Quality Control Report

Consultant **Wahib Medanat** Consultant Engineers
Site Name **Jumana Bint Abi Taleb Basic Mixed - Marka**
Package **Package 2**
Contractor **Dijlah Est. Construction Co.**
Tender No. **10/2019/USAID/SKEP/3/2**

Rep No. **QC-23 16**
Date **27 / 03 / 2022**

Gaps within the block walls over the suspended ceiling at wet area

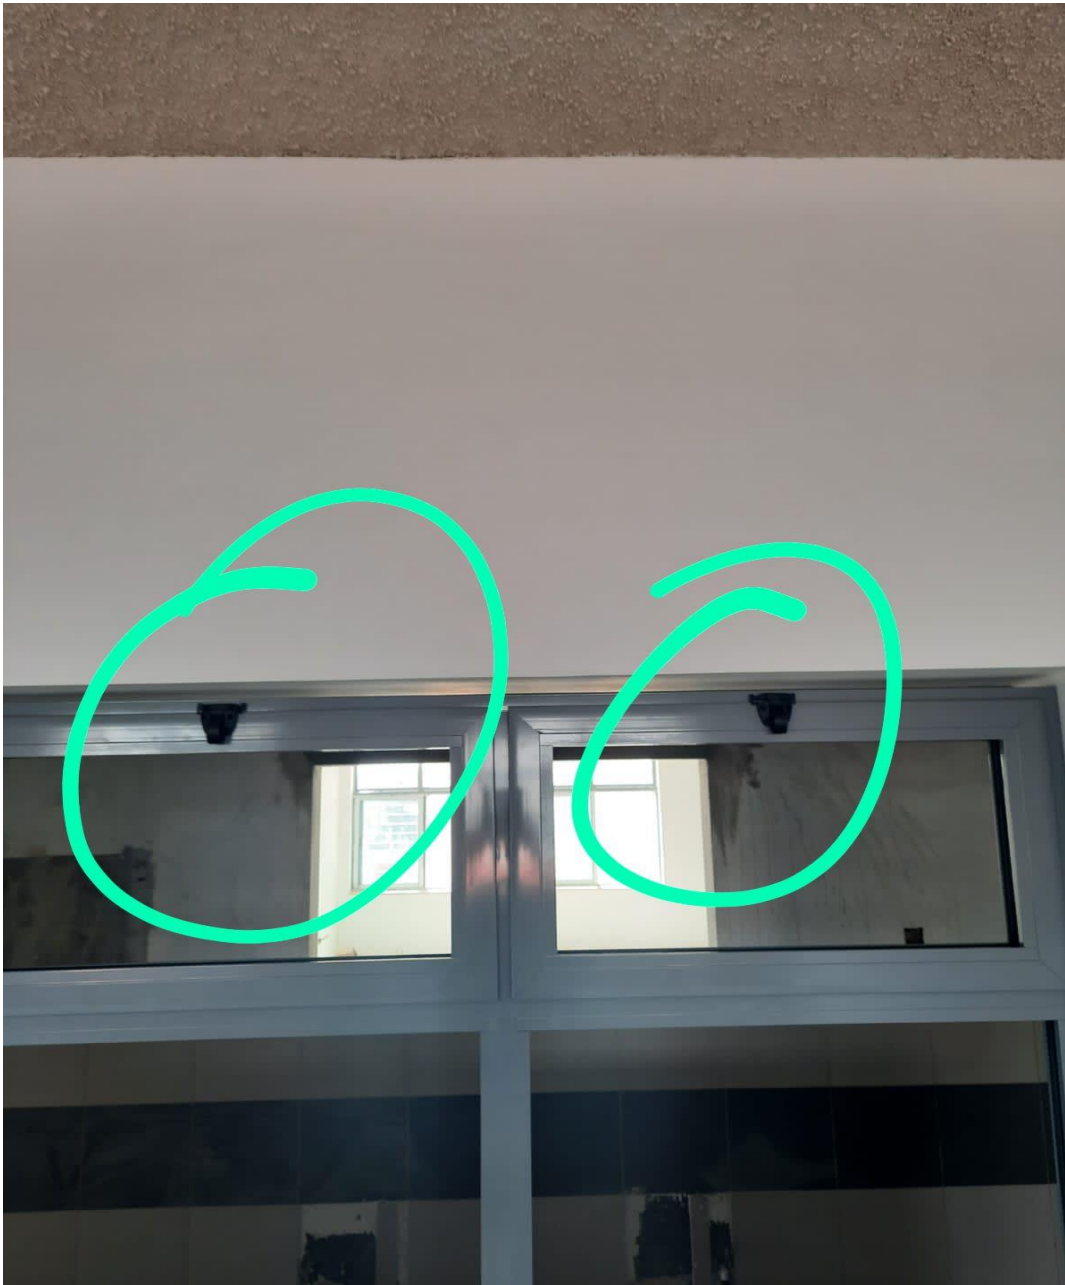
Description of Non Conformance	Corrective Action	Required by / When
<p>1. Gaps within the block walls at the wet area- multi-purpose hall.</p> <p>2. The following defects are observed in the installed aluminum windows:</p> <ul style="list-style-type: none"> - Dimensions are not copatible with the window opening dimensions. - The accessories are not stainless steel as required. - The used sealant is of white color and not approved. <p>3. The defects in granite cladding and inclined skirting still existing.</p>	<p>1. Rectify.</p> <p>2. Modify/Rectify.</p> <p>3. Rectify/Replace.</p>	<p>The Contractor/Without delay</p>
Report Prepared by	Hassan Shaqbua, Supervision Quality Control Manager	
Contractor's Response	The Contractor responded to remark no. 1.	
Notes
